Re: Recommendation to Allow Fence Height Over Standard Size at Cokers Corner Minor Sub

also known as 1680 Sunnyside Dr.

Figure 1

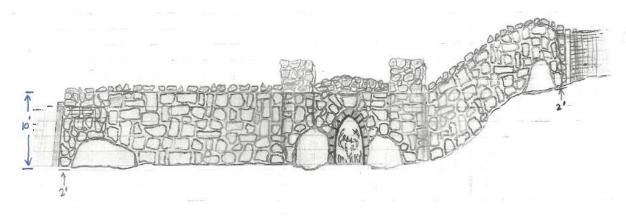
The owner submitted multiple designs for a stone wall with multiple turrets. Staff reviewed the illustrations and determined that it did not meet the design code section 12-7-4 (E) as it was not in harmony "with the adjacent building architecture and the surrounding natural environment"

The applicant revised the drawings and resubmitted them without the turrets (figure 1) and based the design on a nearby fireplace relic (figure 2) and stone wall that is on the adjacent property (figure 3). Also, the stone topped walls resemble the bridges near the North Inlet trailhead (figure 4). The main stone wall would be 10' high and connects to the existing 8' game fence; the height of the wall above the gate itself would be total height of 14'. The applicant states that the idea here is that it would be patterned after the "ranch" entry gates seen all over the county. See Exhibit A for precedent images from the applicant.

The height of the fence is over the allowable 8' height and must be reviewed by the planning commission based on the design requirements listed in section 12-7-8 of the Town Municipal Code. If approved, the applicant must submit a building permit for review and approval by the Town and the County prior to construction of said structure.
